## PUBLIC COMMENTS FOR IBR JOINT ADVISORY GROUP

*Received between August 27, 2025 and December 16, 2025*

**Email Subject:** Joint CAG/EAG Public Comment

Based upon the presentation today I wanted to comment on the Shared Use Path (SUP). On the Washington side it has **far too much** out of direction travel and dark (under freeway/structure) spaces. Its start and end should be directly connected to the waterfront and the trails to the north - not adding substantial out of direction travel to users the east-west user and disconnected substantially from the north-south user.. The function of the SUP will be lost or depressed with non-direct linkages. Integrating with the existing walk and cycle paths directly is essential to function. Things to be considered:

**Figure 1. Bike runnel schematic.**

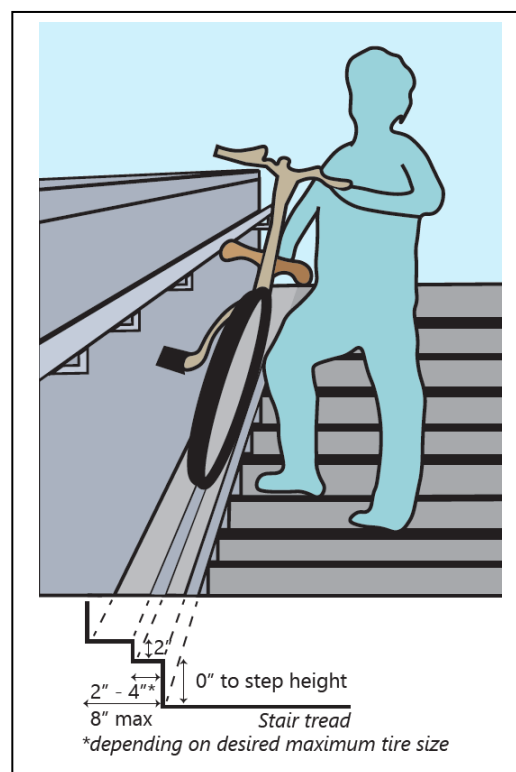
3. Utilize stairways to directly access walkers to the Vancouver Waterfront. Take advantage of the features for cultural representation/art in the stairway design. Include bicycle runnels (attached).

- Material: can be formed in concrete or metallic channels (typically L-shaped)
- Position: should be on both sides under the hand railing, out of the walking area of the stairway
- Width: typically, 2-4 inches wide (.05 to .10 m) for runnel surface which may be flat or channeled. The outer edge can be typically less than 12 inches (0.3 m) from the wall but needs to be no more than 8 inches (0.2 m) from the outer face of the railing.

- Height (lip): typically, 1.5 to 2.5 inches height to control the wheel position (.04 to .06 m)
- Non-slip: gripping runnel surfaces are important for safety, particularly in the downhill direction (avoid smooth metal or polished granite or adhesive tape which can become a maintenance issue)
